Detailed Plan Project Description and Owner's Statement Of Intent For Gordon Knoll 1220 E. Locust Street Milwaukee, Wisconsin

Description of Site Revisions for Grading and Landscaping of the Front and Rear Lot Areas For Gordon Knoll 1220 E. Locust Street Milwaukee, Wisconsin

Response to the Whitnal Knoll Neighborhood Group For Gordon Knoll Landscape Plan Revisions (dated April 25, 2005)

25 APRL 2005 - REV FOR NEW RETANBLE OF PRICE SCHOOL WITH OF BUILDING. IS MAY 2005 - ACS P RESPOND TO NEIGHBO A D (262) 69: -3430 \circ S NERS S ਜੂ ਦੇ T D I A S S O C I A T ARCHITECTS, ENSINEERS, P 1285 SUMVINEDEE ROAD PEWABEEE, WI 53072 (2

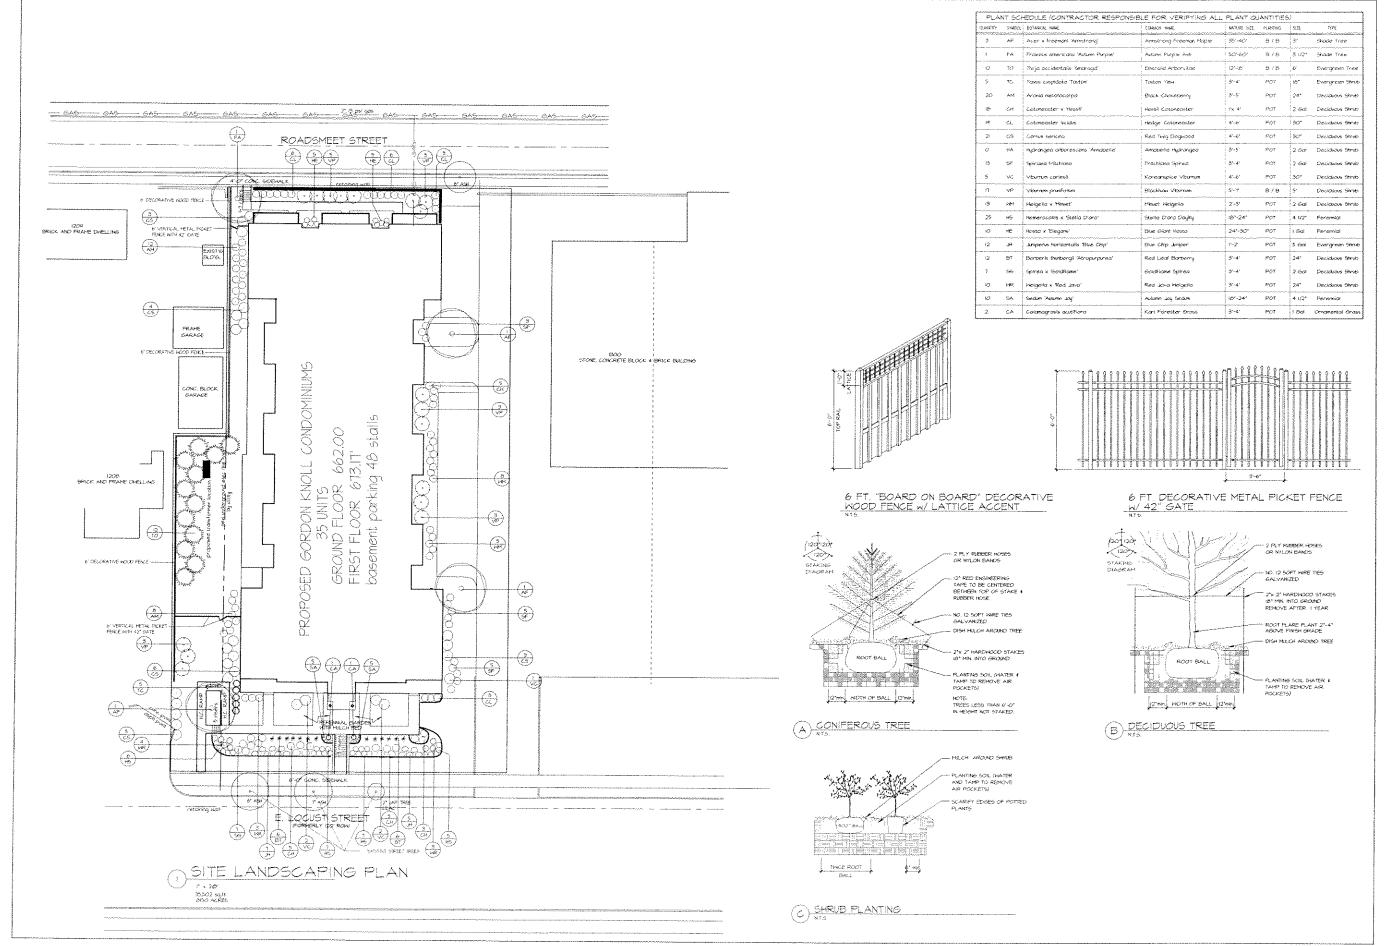
Q: We would like to see the north elevation for the retaining wall detail. Is retaining terraced? What is the height of the wall? Will present bowing of wall be addressed?

Q: Fence must be closed at this location. This item is non-negotiable. Existing chain link fence must be secured to retaining wall no gap permitted.

Q: A new chain link or wooden fence to stop pedestrian access to Roadsmeet.

Q: Handrail design and color to be consistent with other railings on building.

Q: Concealment of black plastic drain pipe in center of north side of building.

Q: Will landscaping improve runoff drainage along west side of site.

A: Three photographs of the existing wall are attached to this letter. They show the existing wall as stepped along the top of the wall to conform to the descending slope of the sidewalk from west to east. The wall varies in height from approximately five feet on the west to 4 feet at the east corner which turns south to abut the building foundation. We propose to raise the northeast corner 2 courses in height (16 inches) to allow more soil for plants being installed at this area and to allow for a 6 foot high chain link fence to be abutted to the retaining wall at this corner. See the notes on photograph #5.

A: In addition to the answer above, the raising of the retaining wall and installation of a taller 6 foot high chain link fence should act to reduce trespassing at his location. The new chain link fence post will be secured to the retaining wall to eliminate the gap that currently exists at this location.

A: See answer given above.

A: All handrails and colors will be consistent. Some of the existing railings are either temporary or still in their primer coat of paint awaiting a finish coat. Weather played a factor in not completing some of the final painting operations last fall.

A; This is a remnant of a temporary drainage pipe and will be disposed of.

A: Yes. The landscape materials selected along this area will be placed to screen the swale in this area and the lawn will provide for drainage flow without soil erosion.
